Project	IEEE 802.16 Broadband Wireless Access Working Group < http://ieee802.org/16 >	
Title	Clarification on the Key Hierarchy for the PKMv2	
Data Submitted	2005-06-08	
Source(s)	Seokheon Cho Sungcheol Chang Chulsik Yoon	Voice: +82-42-860-5524 Fax: +82-42-861-1966 chosh@etri.re.kr
	ETRI 161, Gajeong-dong, Yuseong-Gu, Daejeon, 305-350, Korea	
Re:	IEEE P802.16e/D8	
Abstract	<p>Both an MS and the BS can share the PAK from the RSA-based authorization and the PMK from the EAP-based authorization in the PKMv2. Two keys, the PAK and the PMK, are used to derive the AK. The PAK is used as input data, however, the PMK is used as input key. Since the PAK and the PMK are root keys to derive the AK, both of them should be used as not input data but input keys.</p> <p>This contribution provides key hierarchy for the PKMv2.</p>	
Purpose	Adoption of proposed changes into P802.16e/D8	
Notice	This document has been prepared to assist IEEE 802.16. It is offered as a basis for discussion and is not binding on the contributing individual(s) or organization(s). The material in this document is subject to change in form and content after further study. The contributor(s) reserve(s) the right to add, ame

Figure 131-AK with the only PAK (from RSA-based ~~only~~ authorization process)

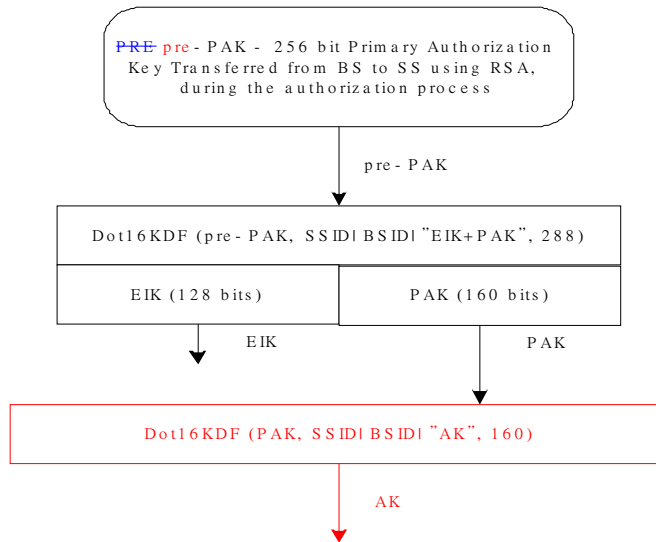
Figure 131 outlines the process to calculate the AK when the RSA-based authorization process has taken place, but where the EAP-based authentication process hasn't taken place, or the EAP method used has not yielded an ~~AAA-key~~ MSK:

Figure 132-AK with PAK and PMK

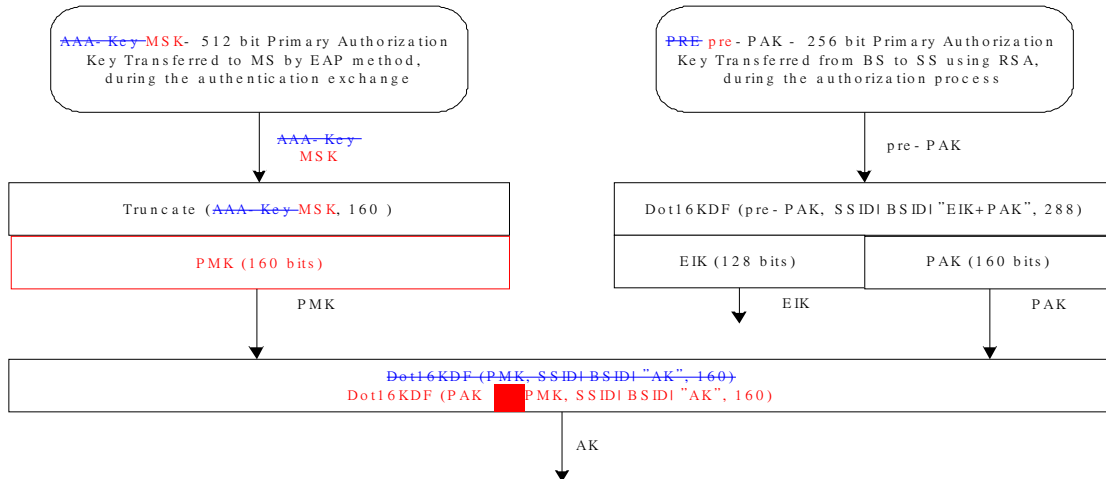
Figure 132 outlines the process to calculate the AK when both the RSA-based authorization exchange has taken place, yielding a PAK and the EAP based authentication exchange has taken place, yielding an AAA-key MSK:

Figure 133-AK with the only PMK (from EAP-based ~~only authentication~~ authorization process)

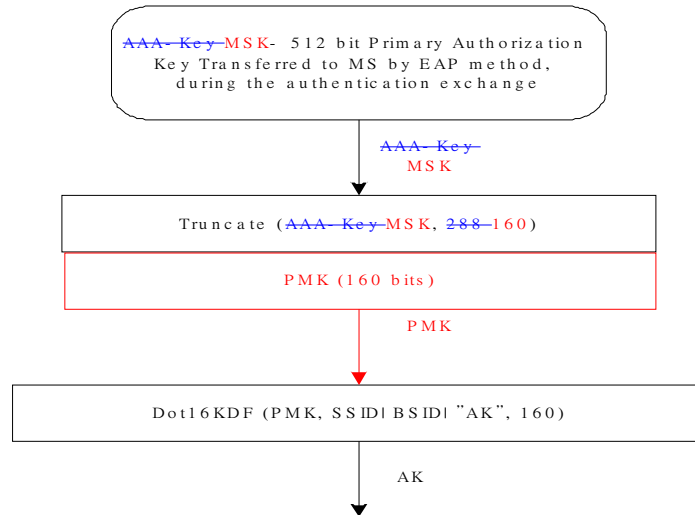
Figure 133 outlines the process to calculate the AK when only the EAP based authentication exchange has taken place, yielding an AAA-key MSK:
